**Re: GE-Pittsfield/Housatonic River Site  
Rest of River  
Comments on EPA's Model Validation Report**

**General Electric Company's Comments on the  
EPA Model Validation: Modeling Study of PCB  
Contamination in the Housatonic River**

**Quantitative Environmental Analysis, LLC  
Liverpool, NY**

**April 19, 2006**

**Figure 9-2. Summary of annual average PCB loadings at various locations along the Housatonic River.**

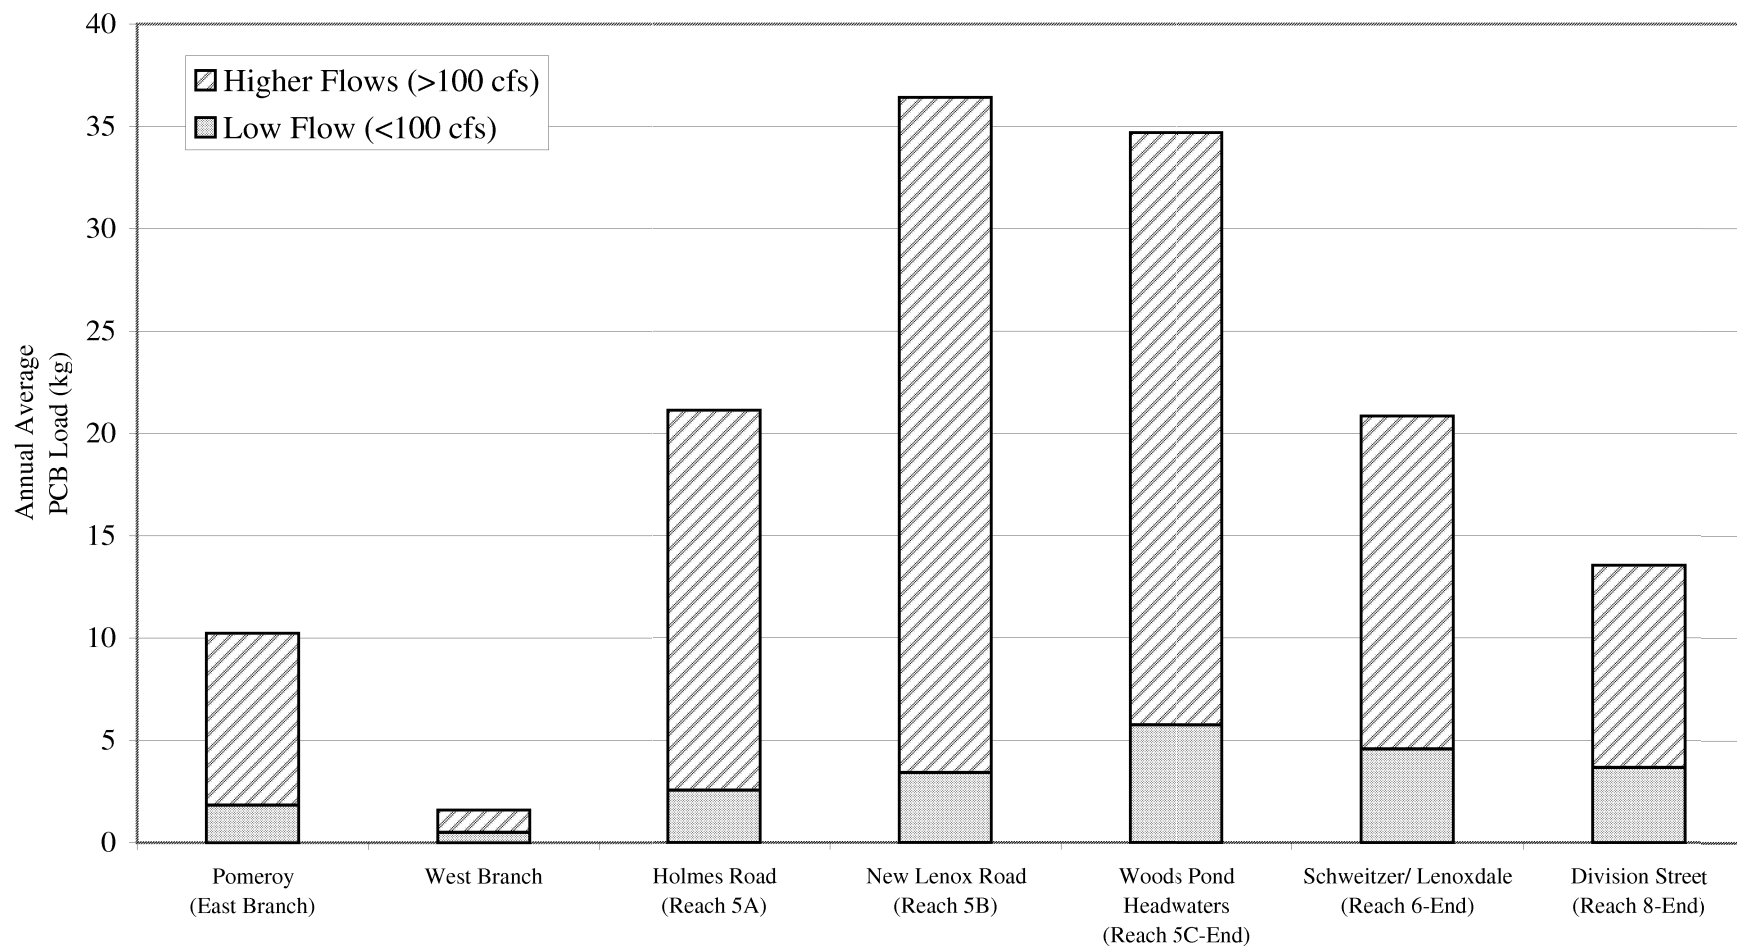
Moreover, the PCB mass balance for the validation period (MVR Figure 6.2-63) indicates that the single largest load of PCBs in the model is advection from the East Branch (i.e., the boundary condition). This result is contrary to: 1) the analyses of available site data presented in the RFI Report, which indicated that sediments in Reaches 5A and 5B are the largest source of PCBs to Reach 5 (BBL and QEA 2003, Figure 9-2, a copy of which is provided as Attachment 3); and 2) the data-based computations developed by EPA as part of its flux analysis (MVR Figure 2.2). In these analyses, there is a net increase in PCB load from the confluence to New Lenox Road, by a factor of two to three. The model validation results, however, indicate a much

**Attachment 4**  
**RFI Report Section 4.5.4 and**  
**Figures 4-21, 4-22, 4-23, and 4-26**

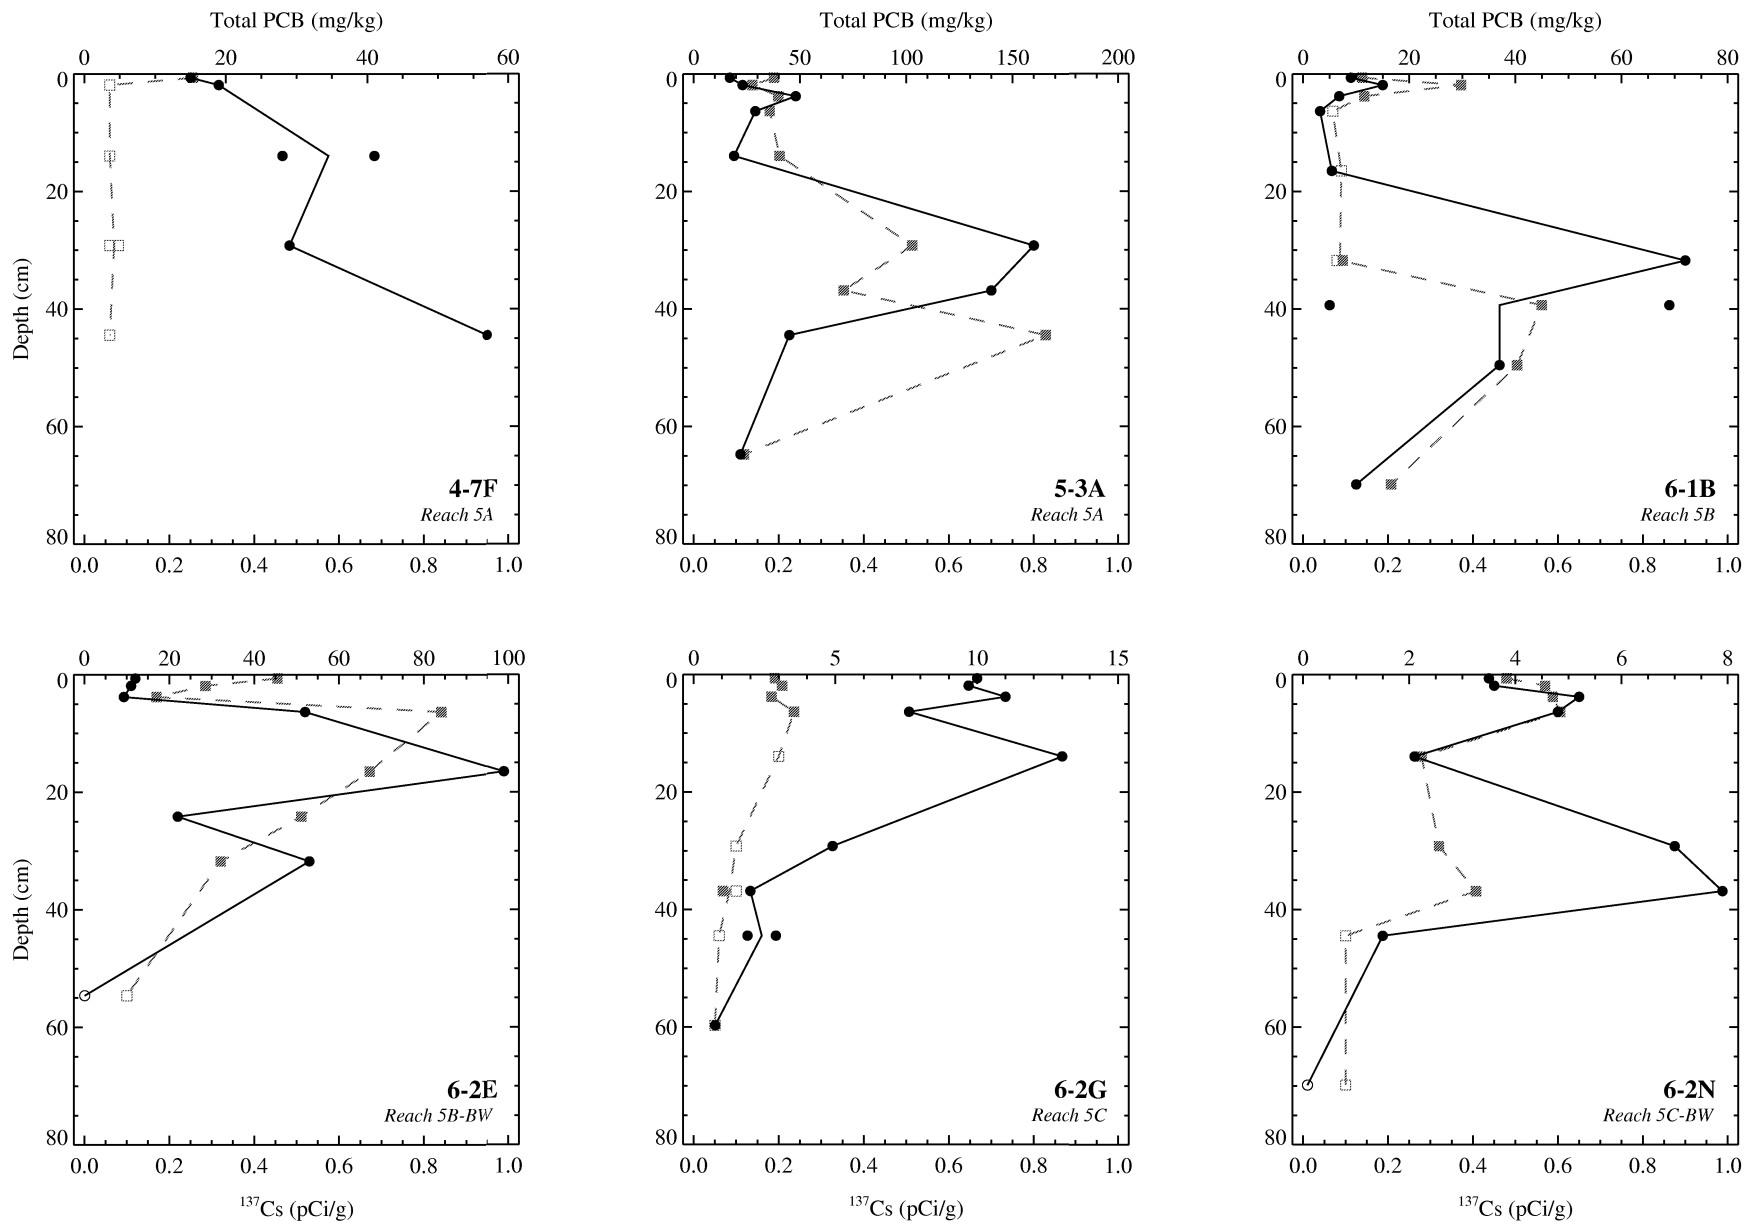
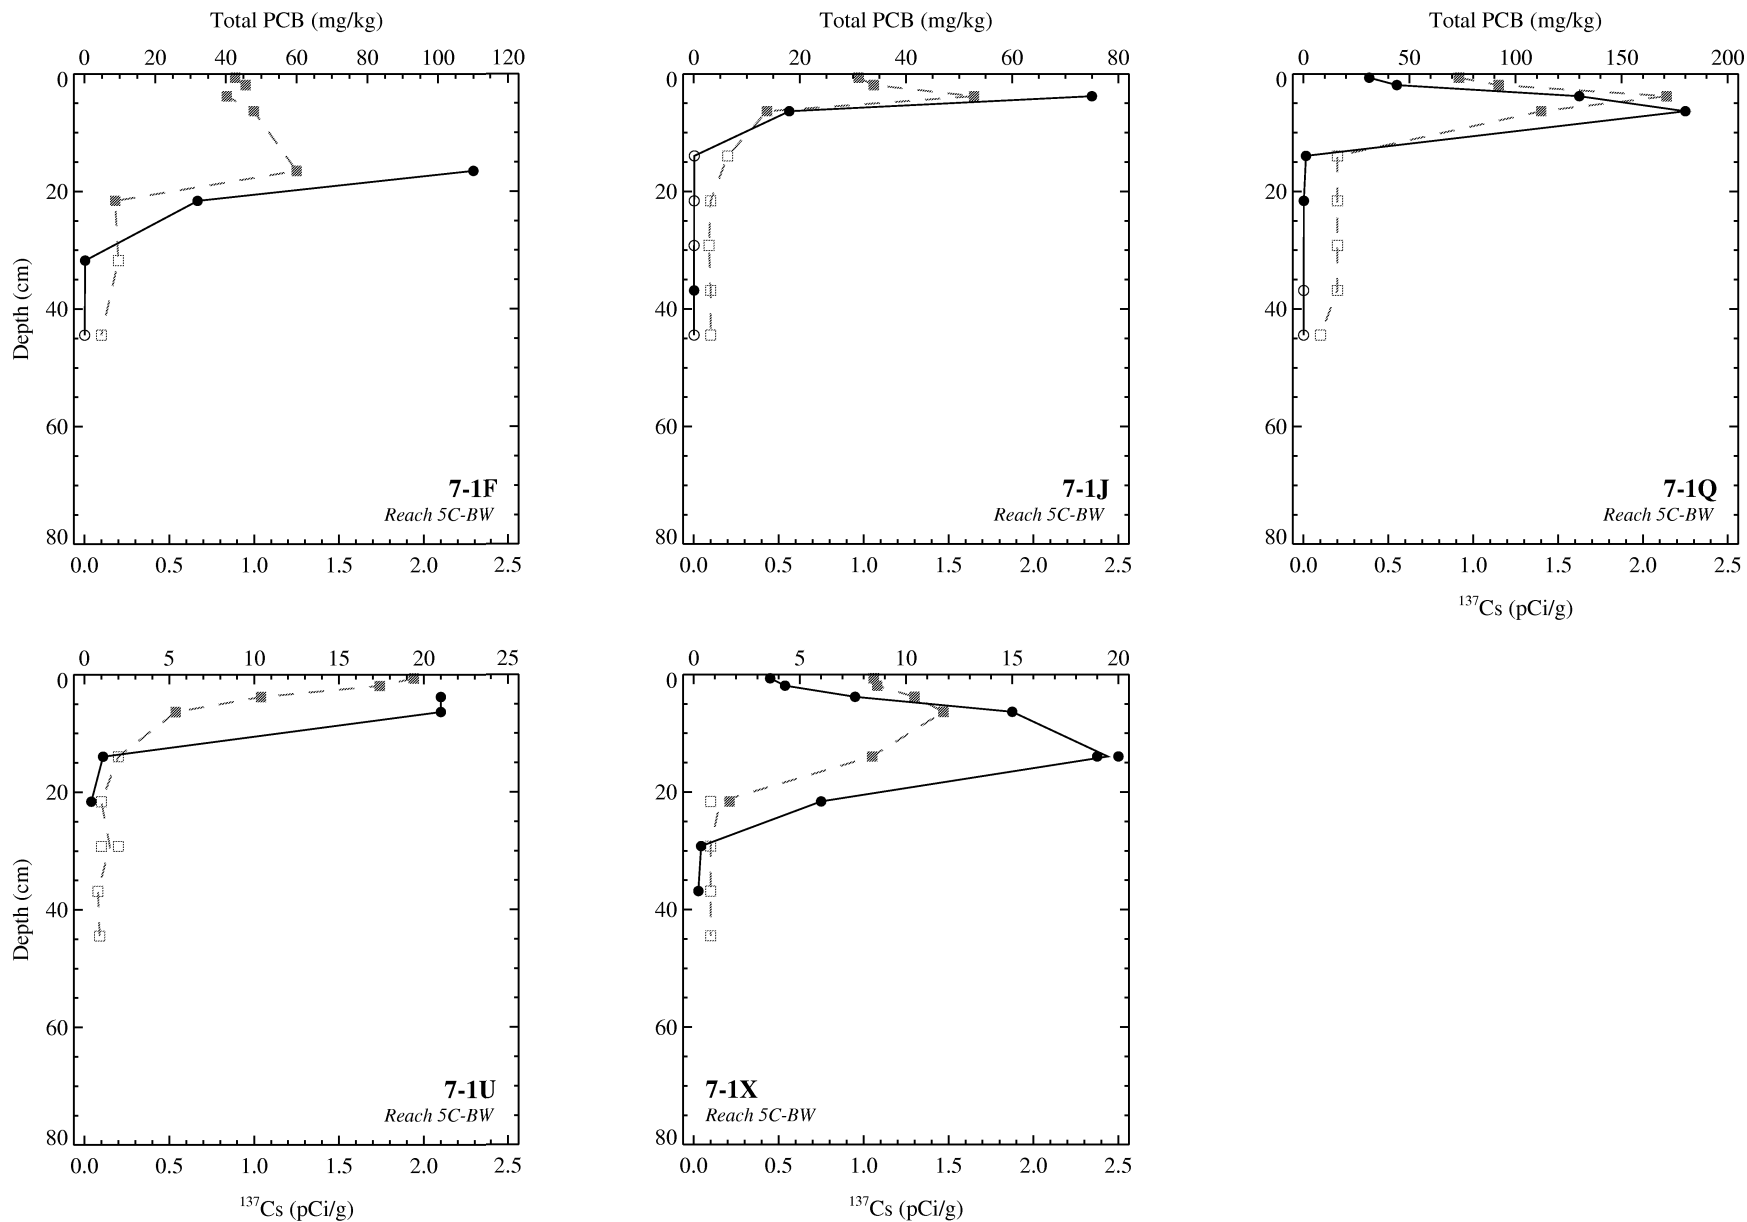
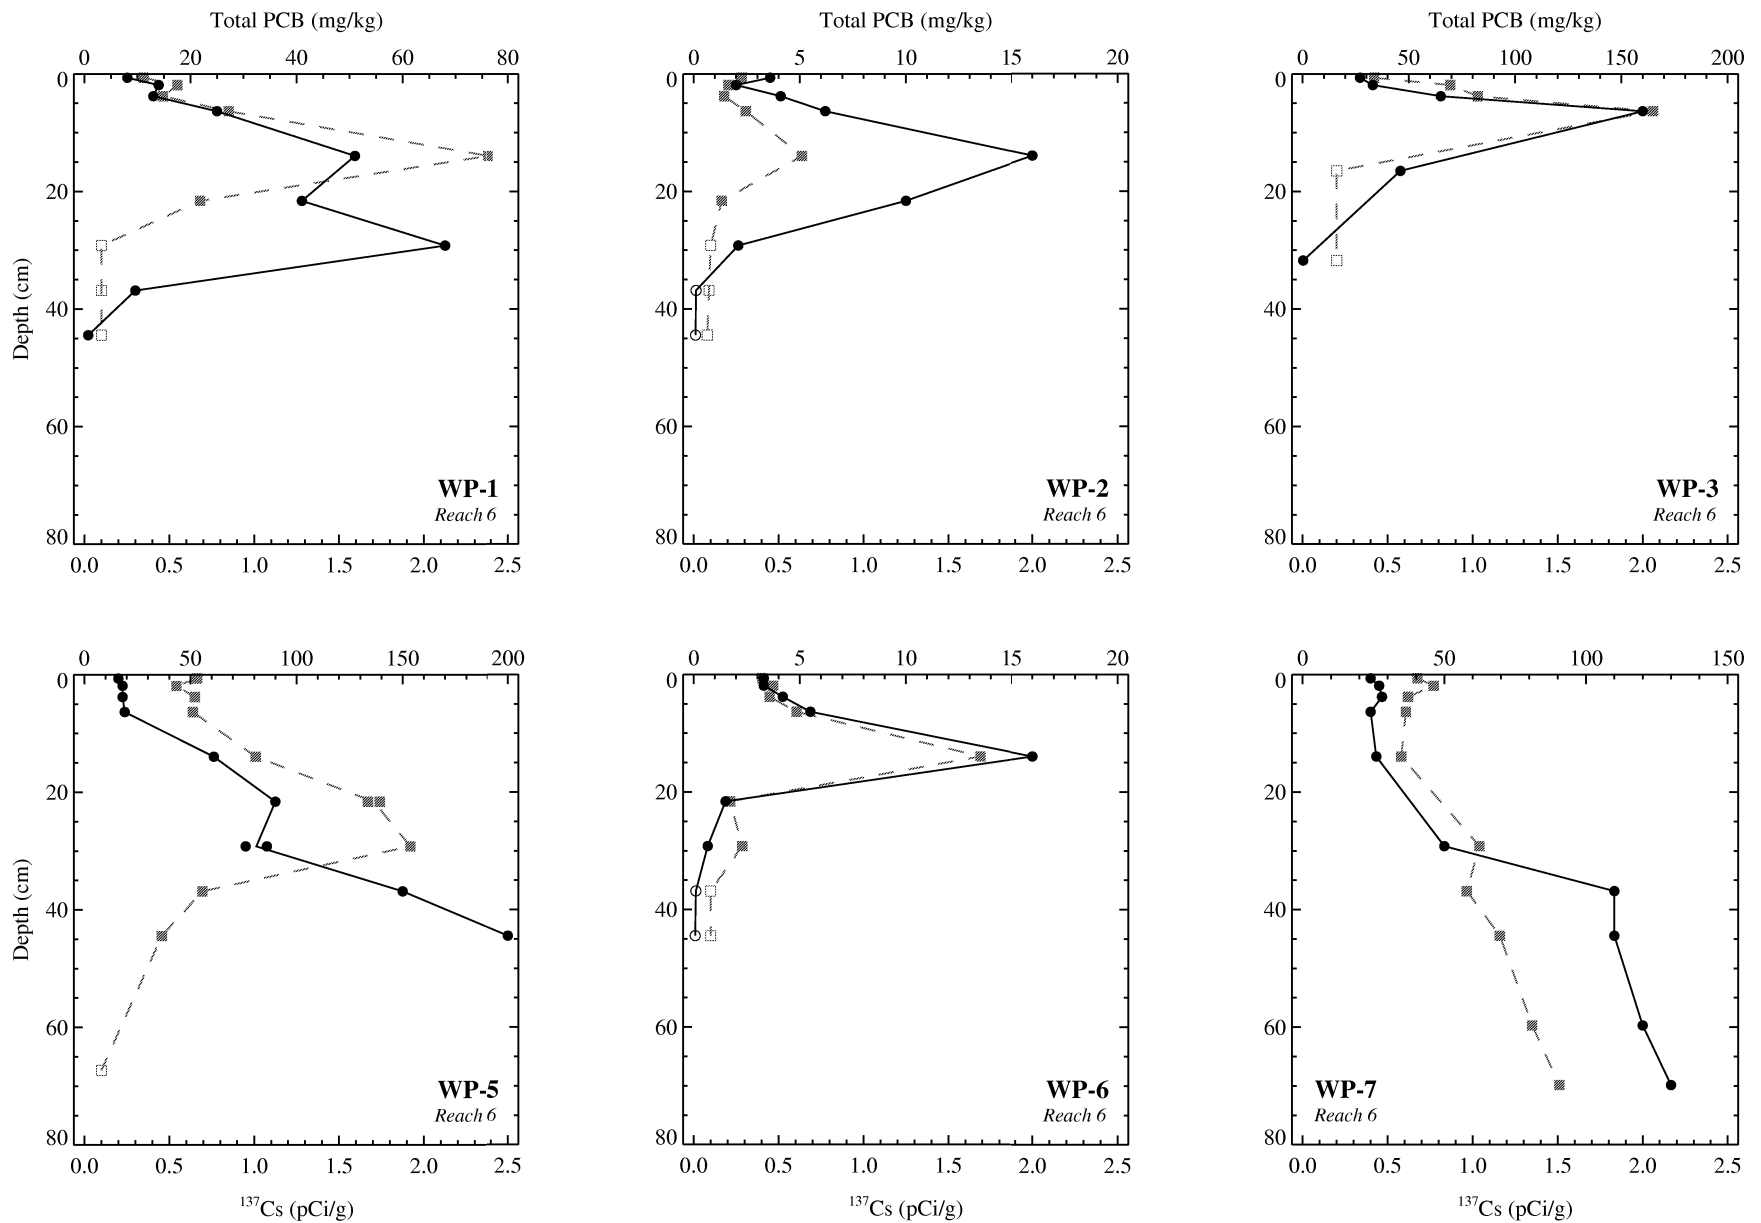
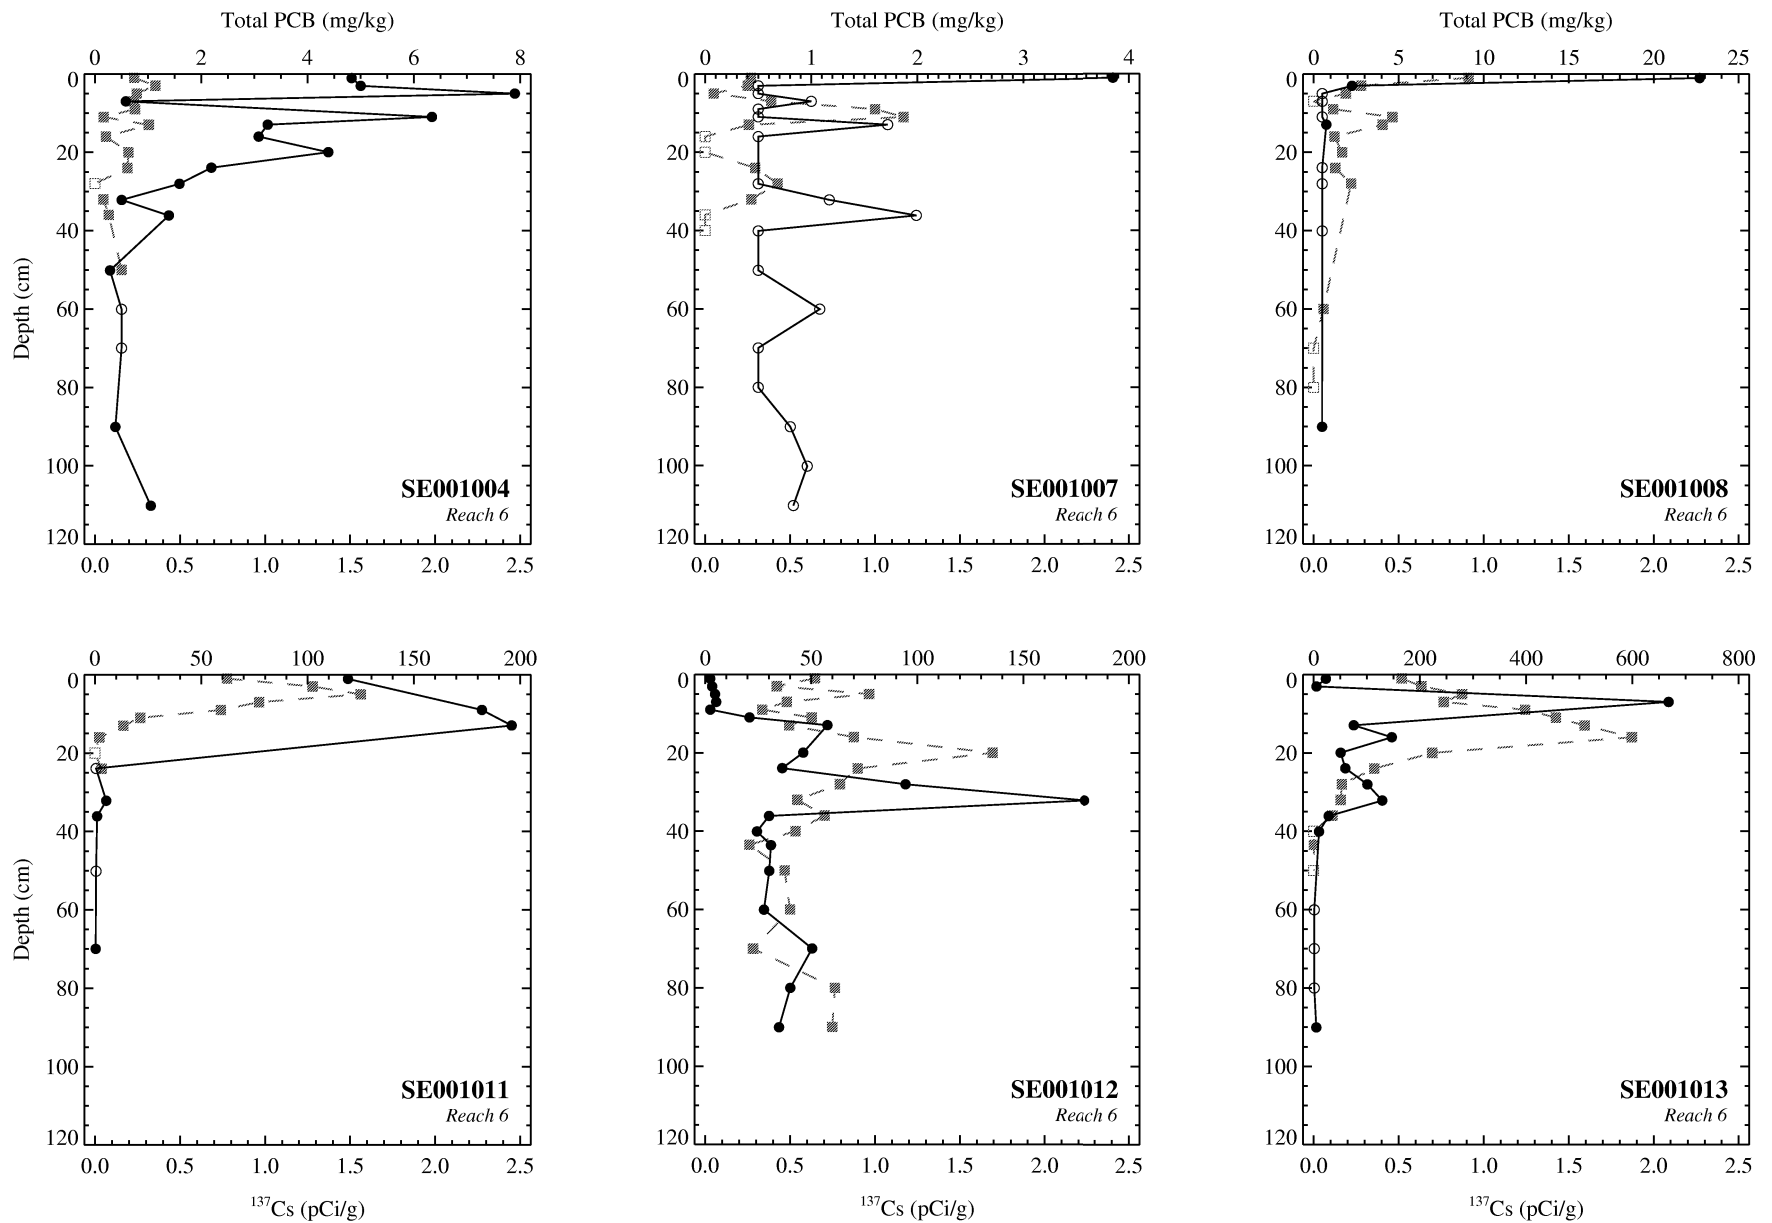
Finally, additional information on temporal trends in sediment PCBs is provided by the finely segmented cores that were collected by GE and EPA from various locations within the PSA (primarily Woods Pond) and dated using radioisotope techniques (see Section 4.5.4 of the RFI Report, excerpts of which are provided in Attachment 4). Model results for sediment PCBs (or PCB concentrations on depositing particles) should be compared to the estimated sediment PCB temporal trends from those cores (e.g., Figures 4-21, 4-22, and 4-26 in the RFI Report; see Attachment 4) as an additional test of the model's ability to reproduce the available information on temporal trends in the system.

- *Rising Pond High-Resolution Sediment Cores* – As described in the RFI Report, two finely segmented sediment cores were collected in 1998 from Rising Pond and analyzed for PCBs and the radioisotope Cesium-137 (BBL and QEA 2003, Section 4.5.4; see Attachment 4 to these comments). Although limited in number, these cores provide additional calibration data for the downstream model. First, the radioisotope data provide estimates of net sediment deposition rates that should be compared with results from the sediment transport model. Second, pairing of sediment radioisotope dating with vertical patterns in PCB concentrations from these cores provide a means of assessing the PCB fate model's ability to reasonably simulate temporal trends in the PCB concentration on depositing particles within Rising Pond.
